ADDENDUM NO. 7
March 31, 2016

Re: Sanford High School and Technical Center
12-067-00

A5.33

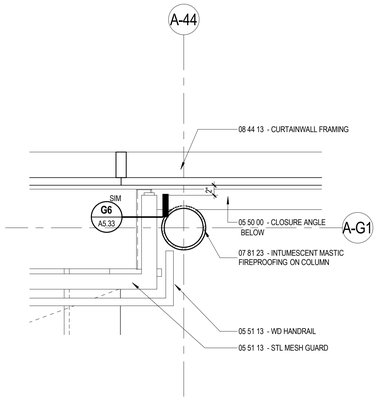
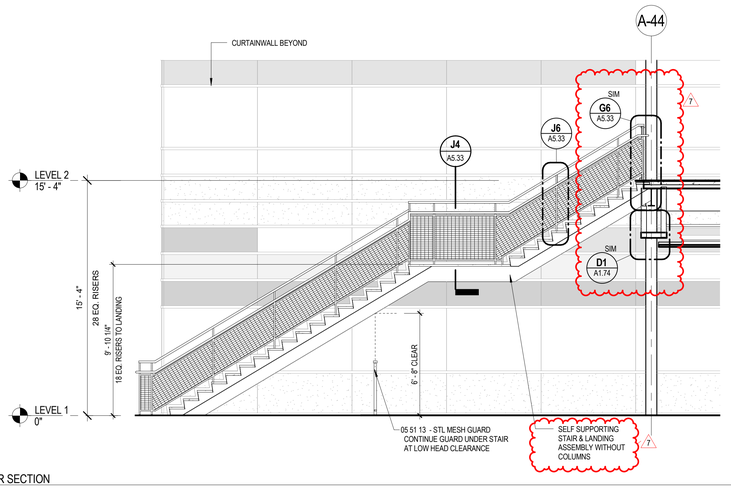
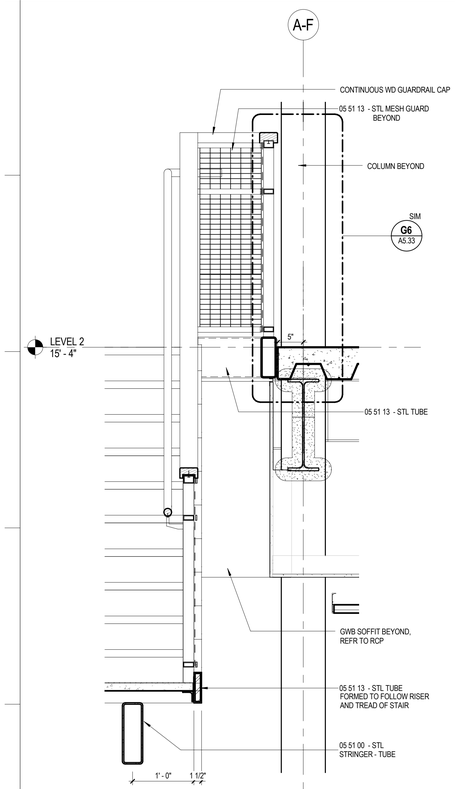
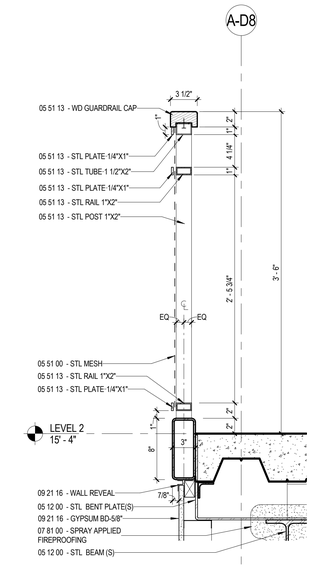
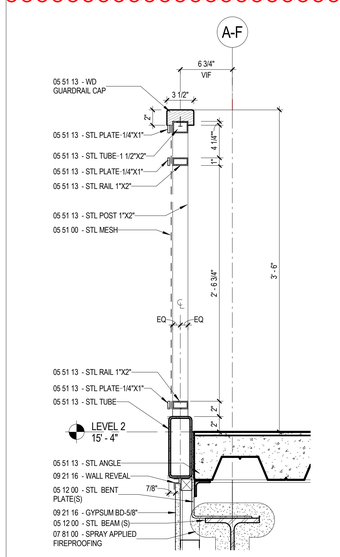
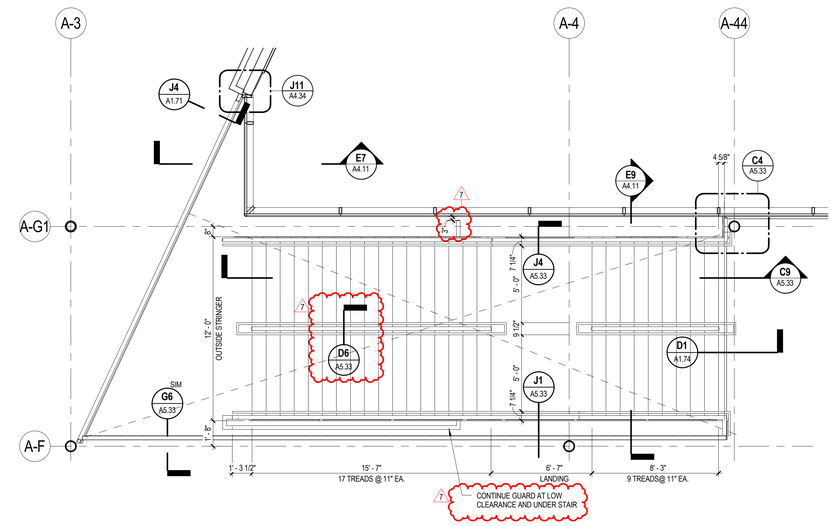
Item No. 7.7 Reference Stair Drawings and Specification 05 51 00: See revised drawings A5.33, A5.34, A5.35 and A5.36 for clarification on handrails. Additional detail keys and keynotes have been added; wood handrails have been changed to steel; a center rail detail for the Main Commons stair has been added; the center handrail at the auditorium seating has been modified. In Specification 05 51 00 2.03 Handrails and Guardrails at Bottom Mounting, all rails should be either 1) welded to the top of a stringer/perimeter steel tube or 2) welded to steel anchor cast into the concrete floor. A cast-in place anchor shall be provided where a guardrail or handrail meets the concrete floor without the use of exposed fasteners or plates.

SKS-02

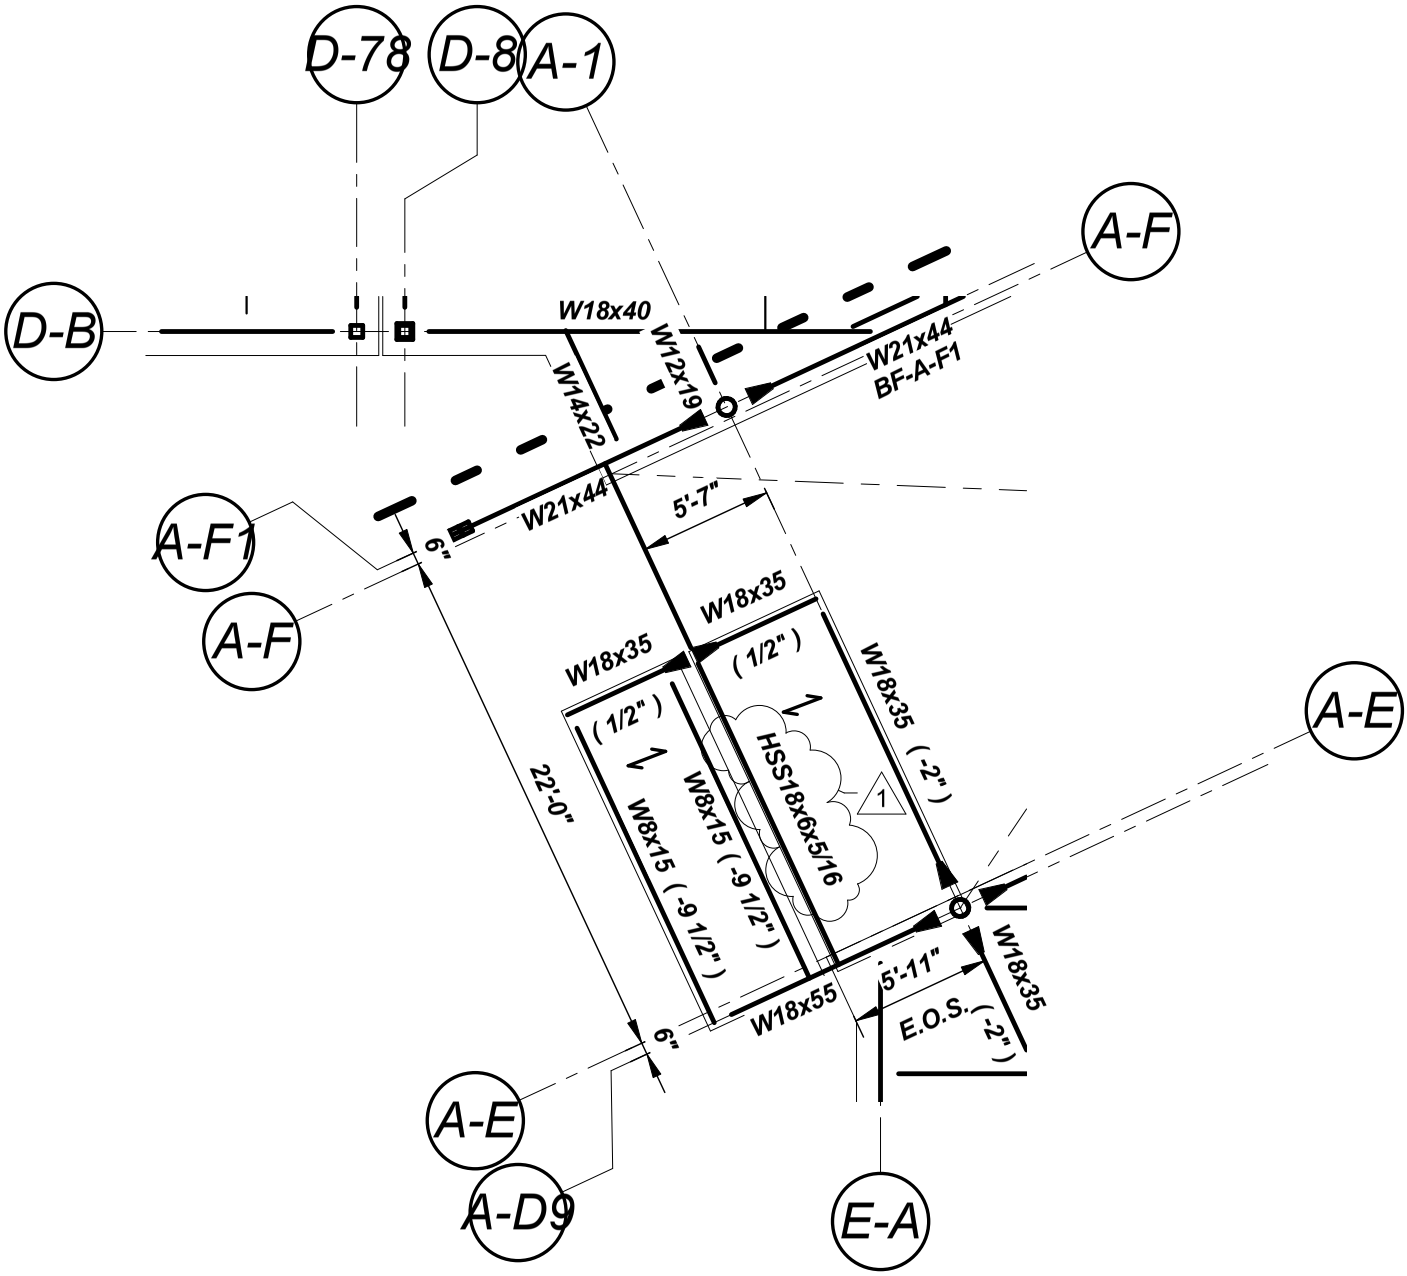
Item No. 7.9 Reference drawing S1.11: SKS-02 is provided to clarify steel tube beam size at entry.
Reference drawing S1.14: Contractor shall provide additional steel tube for supplemental curtain wall support per SKS-03.

SKS-04

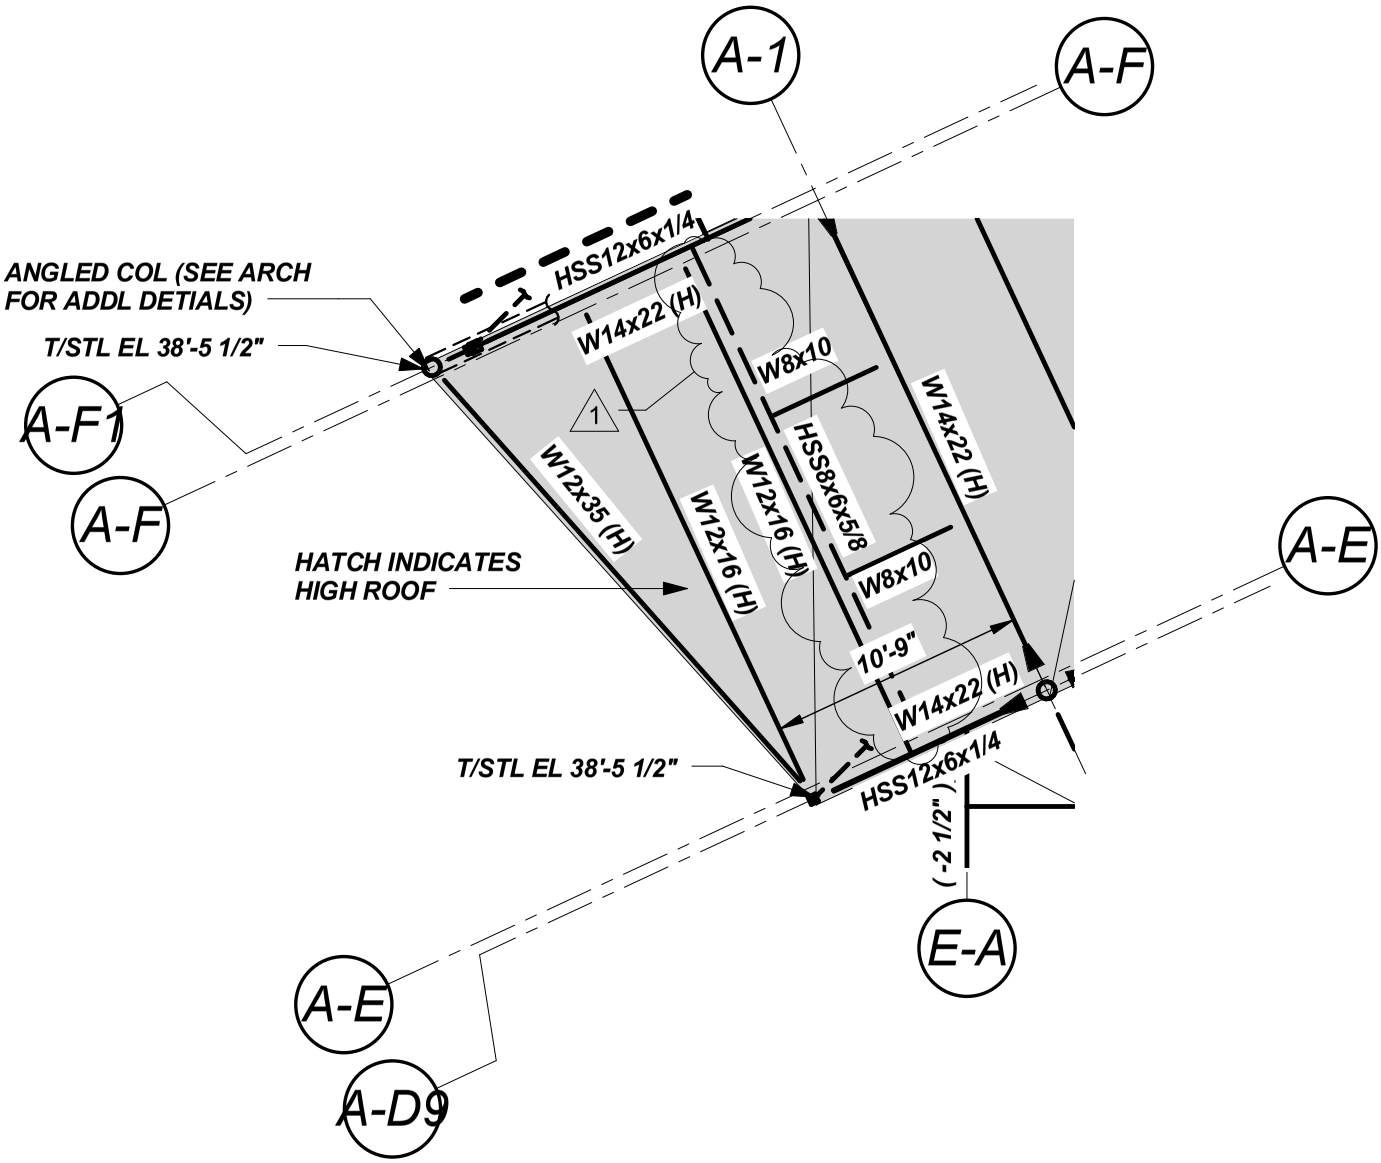
Item No. 7.10 Reference drawing S1.21: Contractor shall provide additional steel tubes for supplemental curtain wall support per SKS-04 and SKS-05.

SKS-06

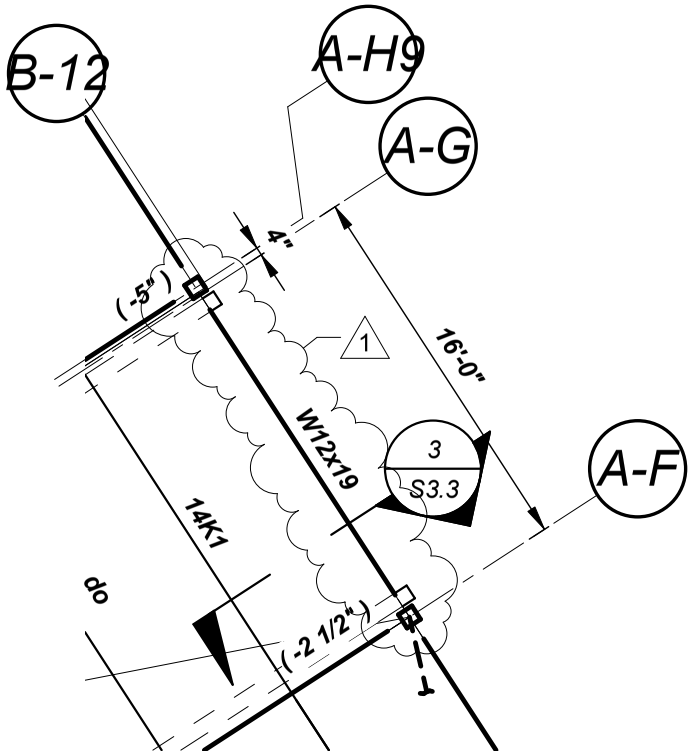
Item No. 7.11 Reference drawing S1.24: Contractor shall locate W12x19 roof beam as shown in SKS-06. Provide section 3 on S3.3 at the roof level at the curtain wall along B12 line from A-H9 to AF.

SKS-07

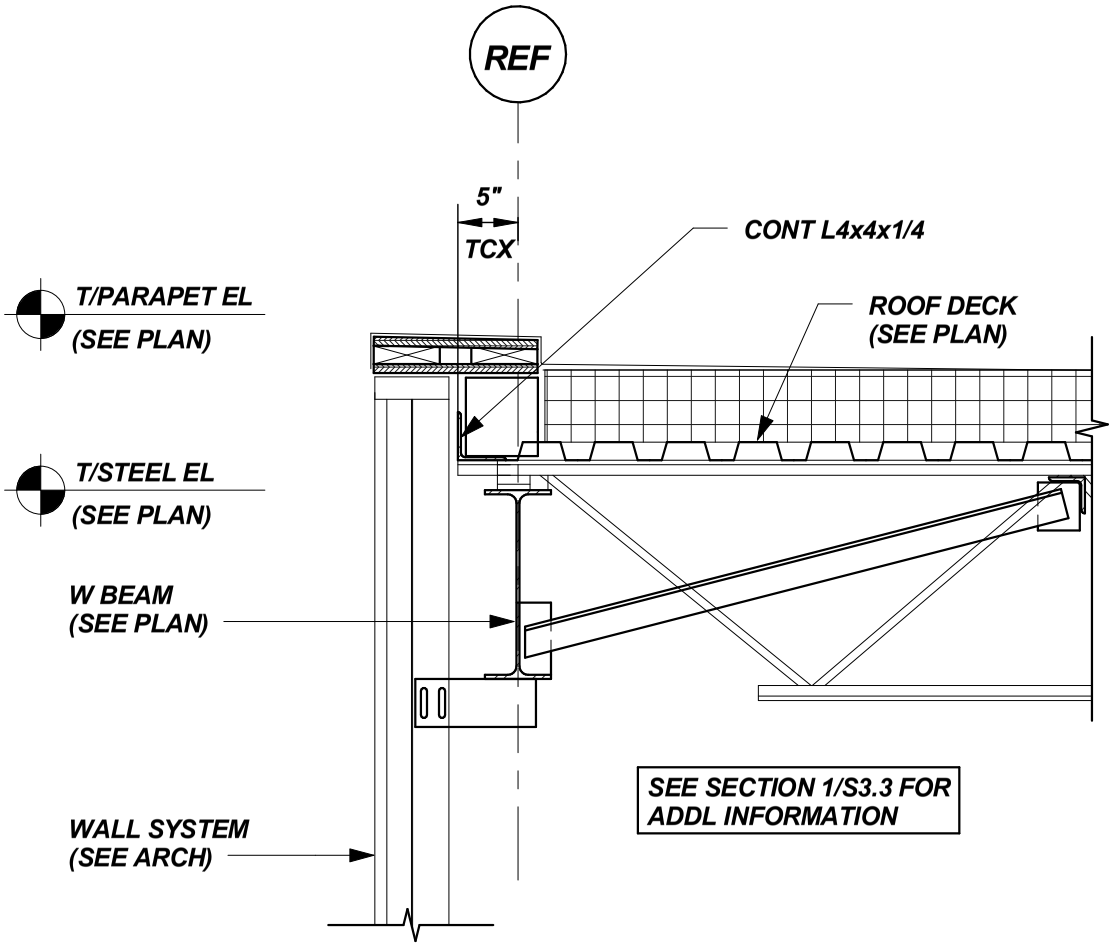
Item No. 7.12 Reference drawing S3.3: Add section 1A to drawings S3.3. This section is shown in SKS-07.

Item No. 7.13 Reference drawing S1.25: Provide section 1A on S3.3 at the roof level at the curtain wall along CE line from C6 to C7.

Item No. 7.14 Reference drawing S1.27: Provide section 1A on S3.3 at the roof level at the curtain wall along DE line from D5.8 to D6.4.

Item No. 7.15 Reference drawing S1.28: Provide section 1A on S3.3 at the roof level at the curtain wall along EA line from E2 to E4. Provide section 3 on S3.3 at roof level at curtain wall along E1 line from EB1 to EC.

ADD SECTION 1A TO DRAWING S3.3-THIS SECTION IS SHOWN ABOVE

PROVIDE SECTION 1A ON DRAWING S3.3 AT THE ROOF LEVEL IN THE FOLLOWING LOCATIONS:
- AT THE CURTAIN WALL ALONG CE LINE FROM C6 TO C7
- AT THE CURTAIN WALL ALONG DE LINE FROM D5.8 TO D6.4
- AT THE CURTAIN WALL ALONG EA LINE FROM E3 TO E4

IN ADDITION, PROVIDE SECTION 3 ON S3.3 AT THE ROOF LEVEL IN THE FOLLOWING LOCATIONS:
- AT THE CURTAIN WALL ALONG B12 LINE FROM A-H9 TO AF
- AT THE CURTAIN WALL ALONG E1 LINE FROM EB1 TO EC
